The National Construction Code Volume One  
Stage Significant Development Application  
RPA Hospital Redevelopment

Health  
Infrastructure

Revision 2

Date: 11 November 2022

Figure No. 3: Plan detailing exposure on Level 3 of external walls of the new East Tower from the existing Main Hospital Building including the Eastern Extension

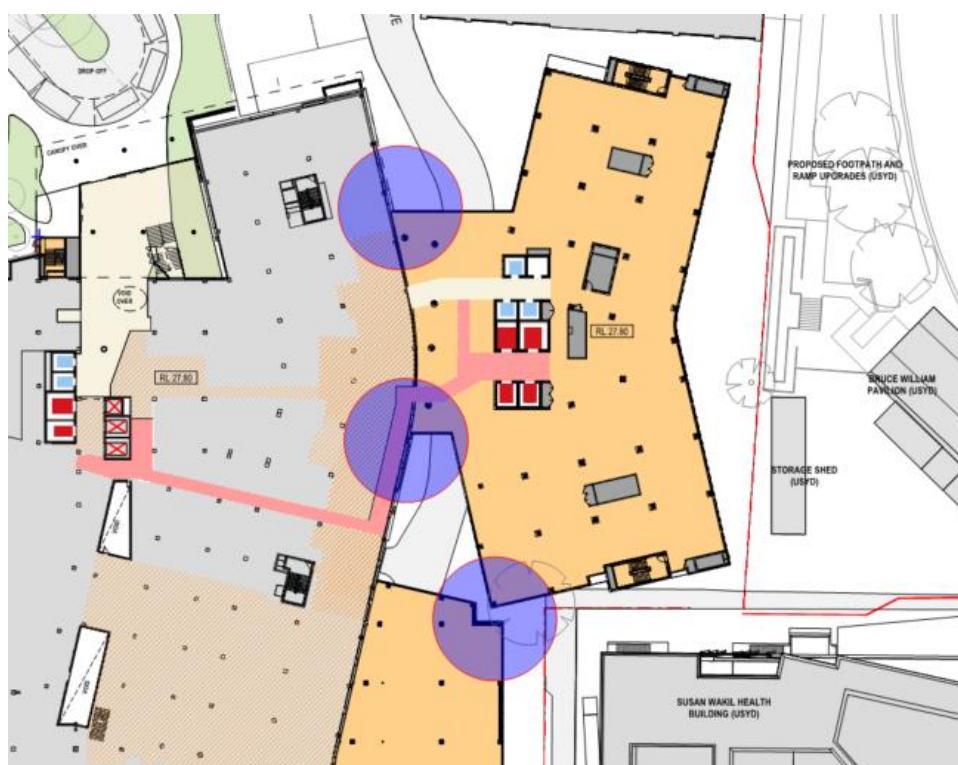
The exposure and protection of the subject external walls and openings of the new East Tower and the existing Main Building will be required to be protected in accordance with the DTS Provisions of the BCA or alternatively will be required to be assessed as part of the Fire Engineering Assessment to be undertaken by the appointed Fire Safety Engineer in order to demonstrate compliance with the nominated Performance Requirements of the BCA.

Figure No. 6: Non-required non-fire isolated stairway connecting Level 3 and Level 4 within the new Northern Entry

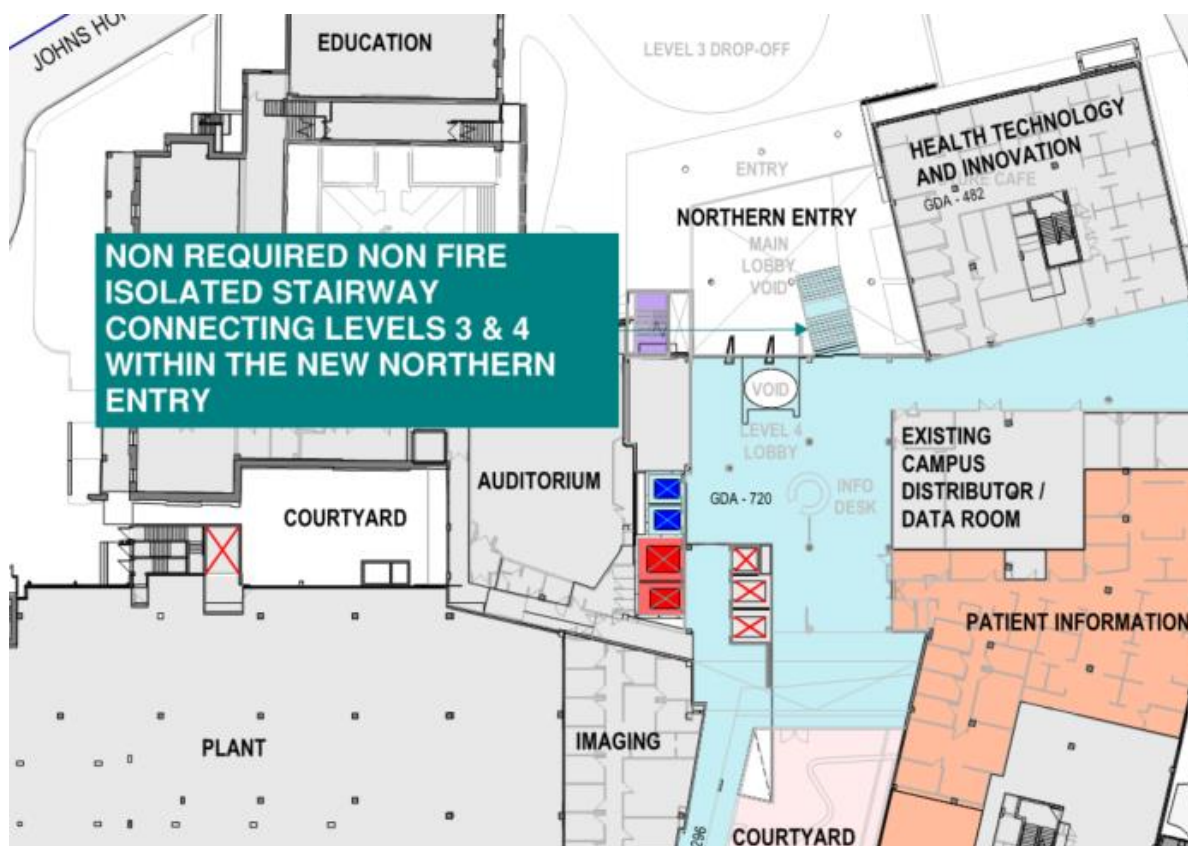
The proposed non-required non-fire isolated stairway situated within the Front of House Atrium which connects Level 3 to Level 4 is permitted in accordance with the DTS Provisions subject to all patient care areas being fire separated from the front of house area in which the open stairway directly connects.

Figure Nos. 14 - 15: Access for a person with a disability through the main entrances on Level 3 & 5

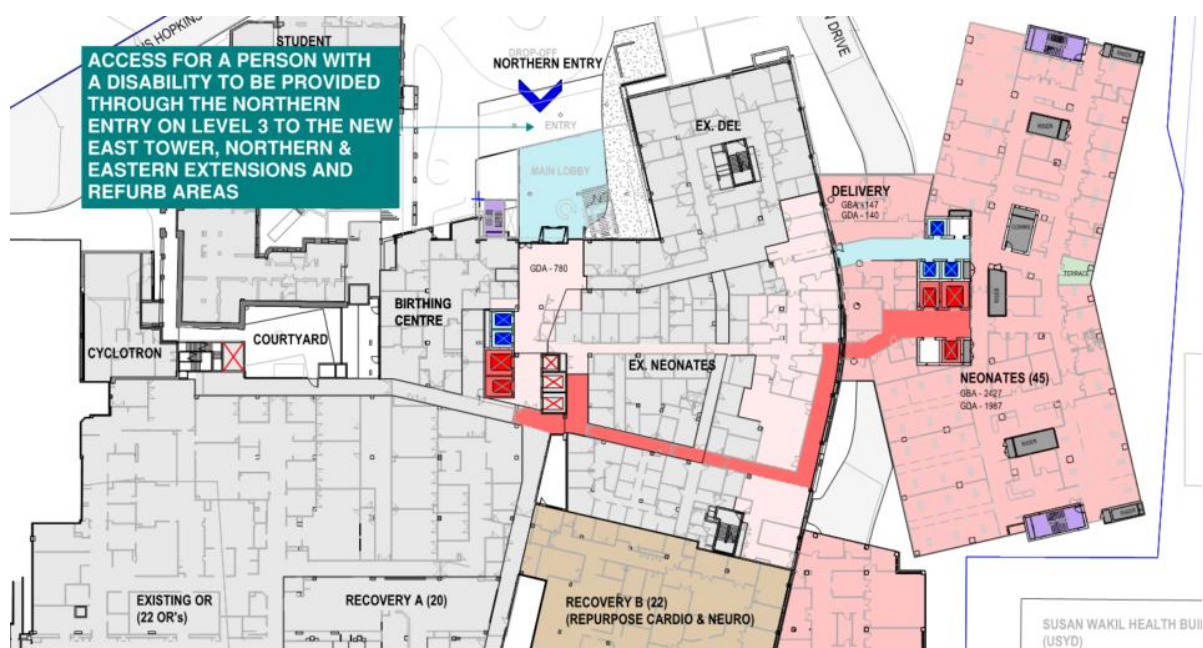
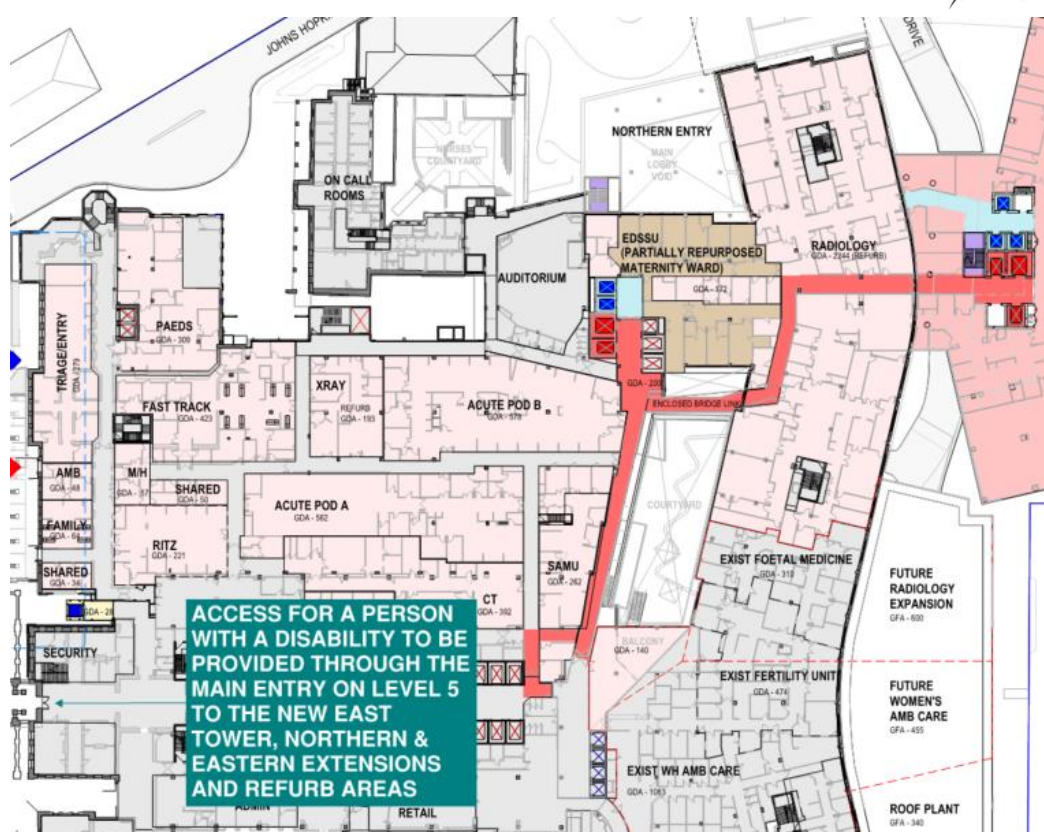
Access for a person with a disability will be required to be provided through the Northern Entry on Level 3 of the building (accessed off John Hopkins Drive) which occupants will use to directly access the new East Tower along with access via the Main Entry on Level 5 of the existing Main Hospital Building (accessed off Missenden Road)

Figure No. 43: Indicative location of Fire Hydrant & Sprinkler Booster on John Hopkins Drive within proximity to the Level 3 Northern Entry

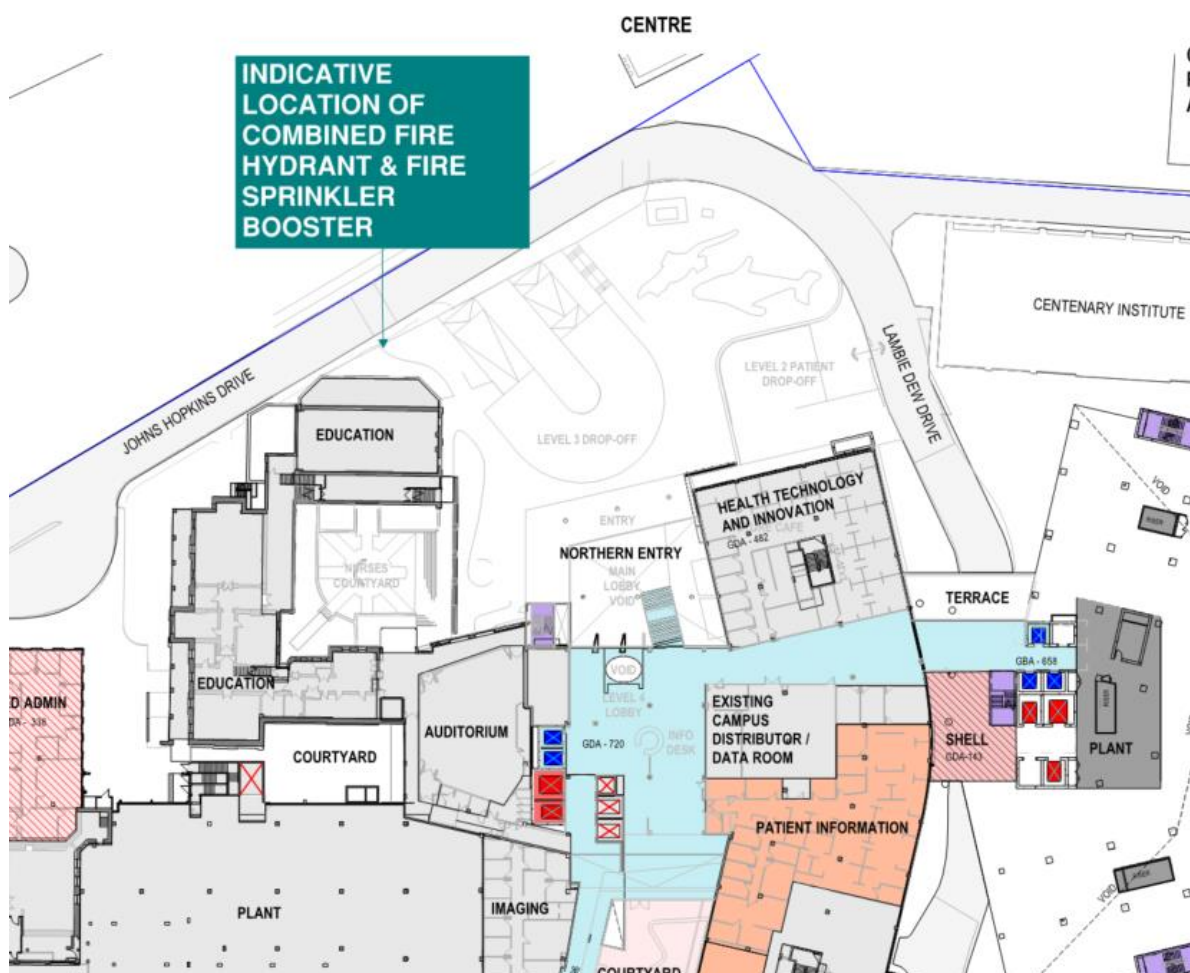
It is understood that the proposed booster will comply with the provisions of AS 2419.1 – 2005 in terms of location with the exception of the fact that the fire hydrant booster will not be located within sight of the main entrance of the building. The proposed location of the booster not within sight of the main entrance of the building will be required to be assessed as part of a Fire Engineering Assessment to be undertaken by the appointed Fire Safety Engineer in consultation with FRNSW in order to demonstrate compliance with the nominated Performance Requirements of the BCA.

Figure No. 44: Indicative location of Fire Hydrant & Sprinkler Booster on John Hopkins Drive within proximity to the Level 3 Northern Entry

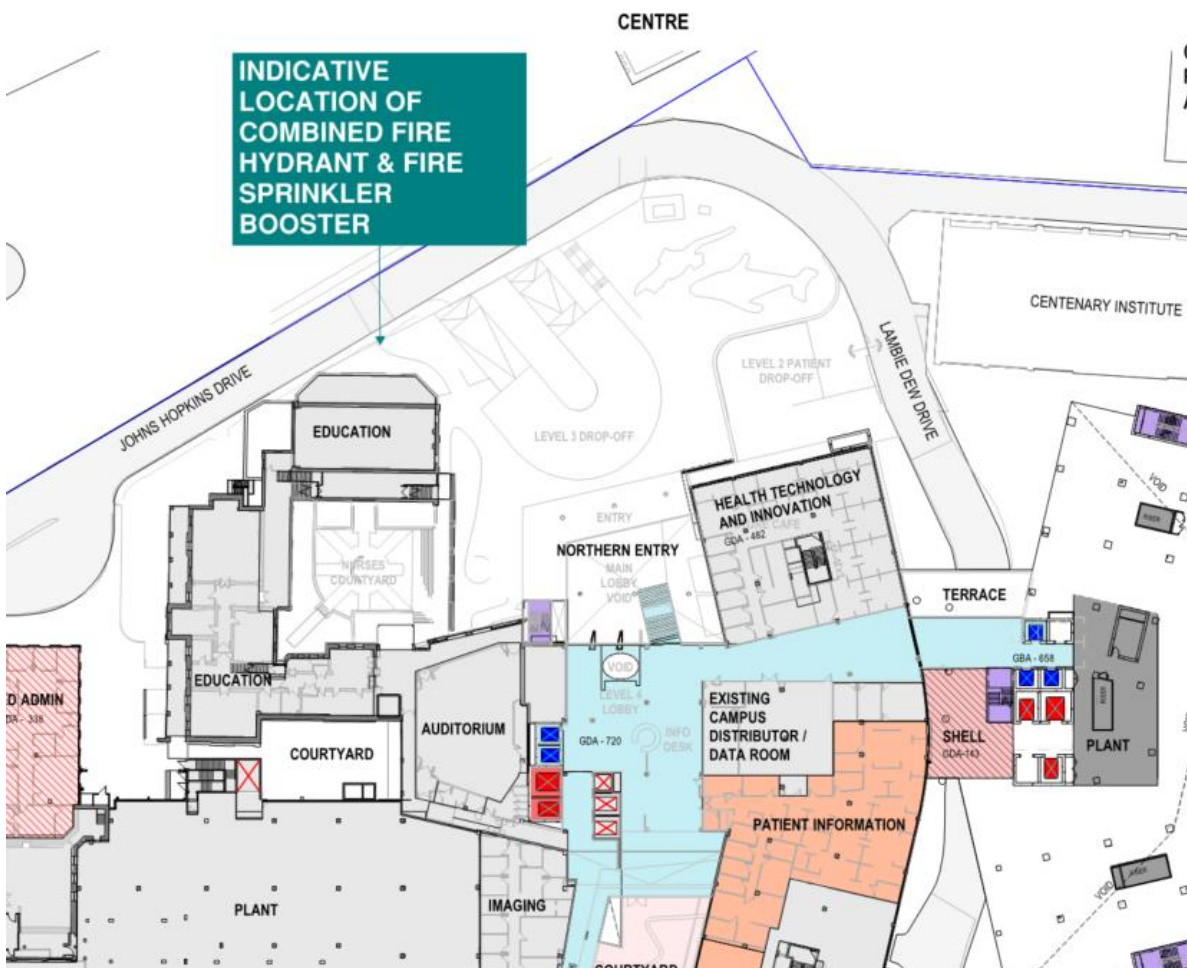
It is understood that the proposed booster will comply with the provisions of AS 2419.1 – 2005 in terms of location with the exception of the fact that the fire hydrant booster will not be located within sight of the main entrance of the building. The proposed location of the booster not within sight of the main entrance of the building will be required to be assessed as part of a Fire Engineering Assessment to be undertaken by the appointed Fire Safety Engineer in consultation with FRNSW in order to demonstrate compliance with the nominated Performance Requirements of the BCA.
